To:	Spring Lake Park City Council	From:	Lauren Walburg, Stantec
	City of Spring Lake Park		
File:	Take 5 Car Wash 8301 University Ave NE Applicant: Rebecca McAllister, Boing US Holdco, Inc. Owners: Muchtar and Fatima Sajady	Date:	June 6, 2022

**Re: Variance, Conditional Use Permit, Site Plan Review - Take 5 Car Wash, 8301 University Ave NE**

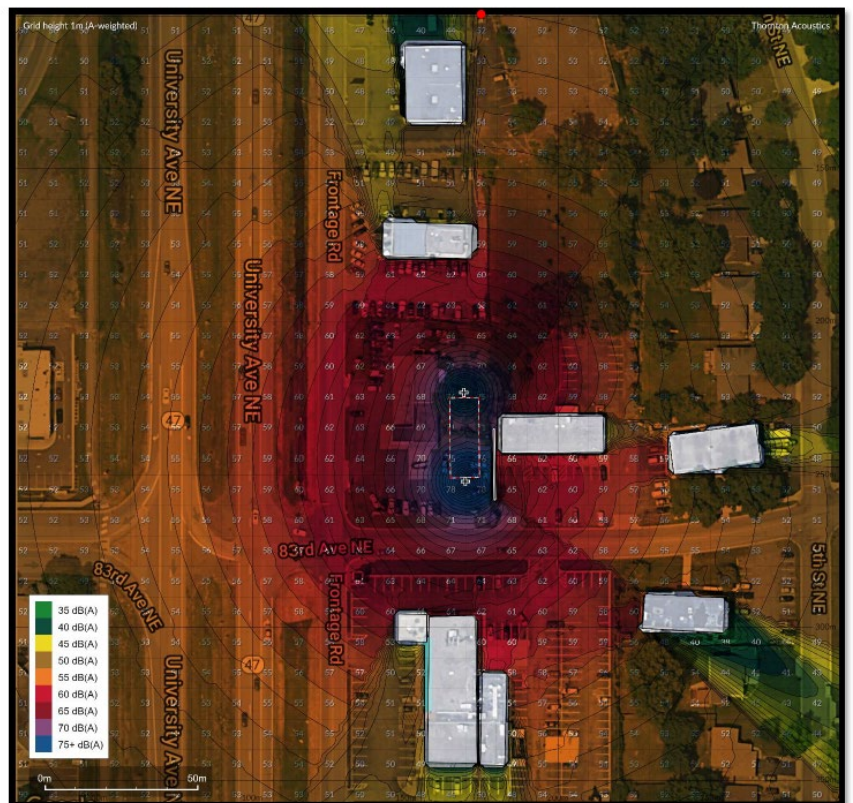
An issue with any drive-through type facility is adequate stacking and making sure that cars waiting in line don't interfere with cars on the adjacent street. The site plan submitted by the applicants shows 12 cars waiting in the pay station lines, and an additional 2 cars between the pay stations and the tunnel. This may be adequate, based on the submitted traffic study and analysis. Should traffic and queuing become an issue, there needs to be clear signage so that stacking onto the road is not allowed. The site plan currently shows stop signs at all exit points to ensure safe exiting of the site. If traffic and queuing becomes an issue, the City Engineer has included a condition that additional signage be installed to indicate queuing on University Ave Frontage road is prohibited.

There site plan shows 16 parking spaces in front of the building in the parking/vacuum area, including 3 standard parking spaces, 12 vacuum spaces and 1 handicap space. This would serve customers and staff for the facility. Spring Lake Park's parking standards require 10 spaces per lane in a commercial car wash. This facility may be different than what was imagined for a "commercial car wash" when the code was written. We recommend relying on the applicants' experience with their facilities to propose adequate parking.

SHEET TITLE:  
**SITE PLAN**

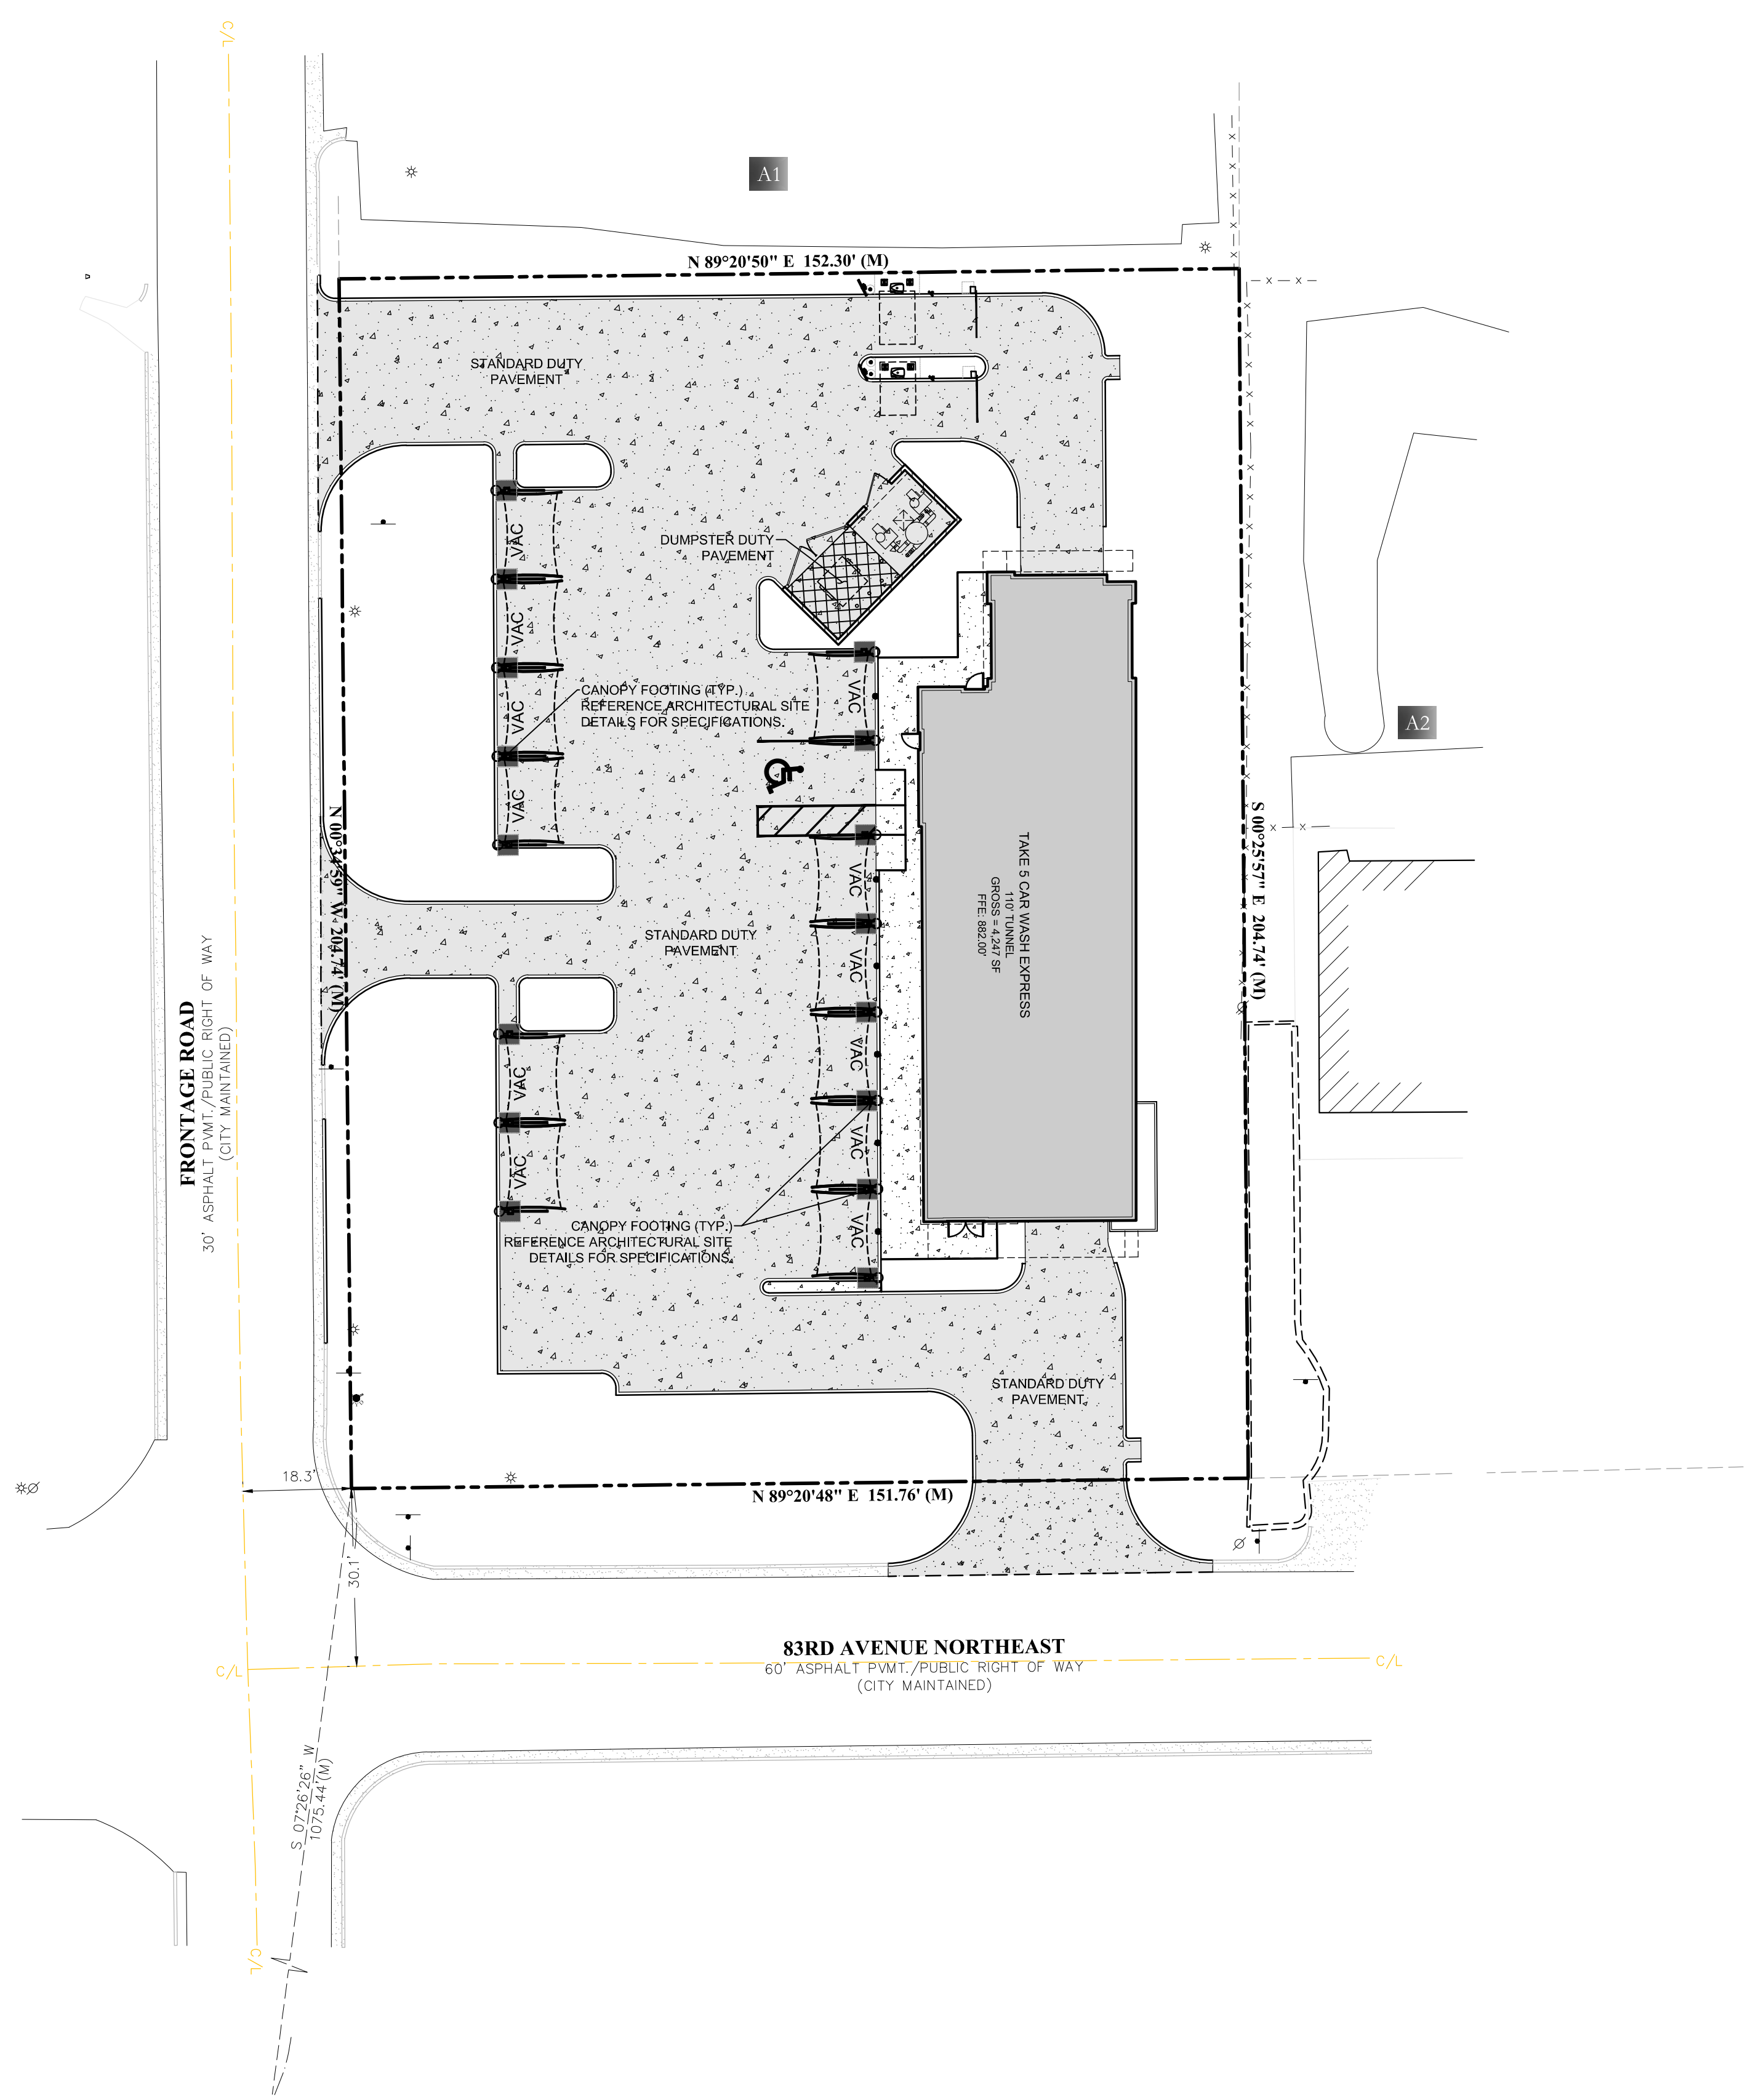
- 9) Traffic. We are concerned about washed vehicles tracking water on to 83<sup>rd</sup> Avenue and possible icing issues. The applicant shall provide improvements to prevent the tracking of water on to the city street. Consider adding heated concrete to the vehicle exit area.

- 10) Grading. Site plan shall be revised to create high points in all 3 driveways to prevent site drainage from draining directly on to 83<sup>rd</sup> Ave. NE or University Service Drive. Utilize proposed green space(s) for stormwater management.
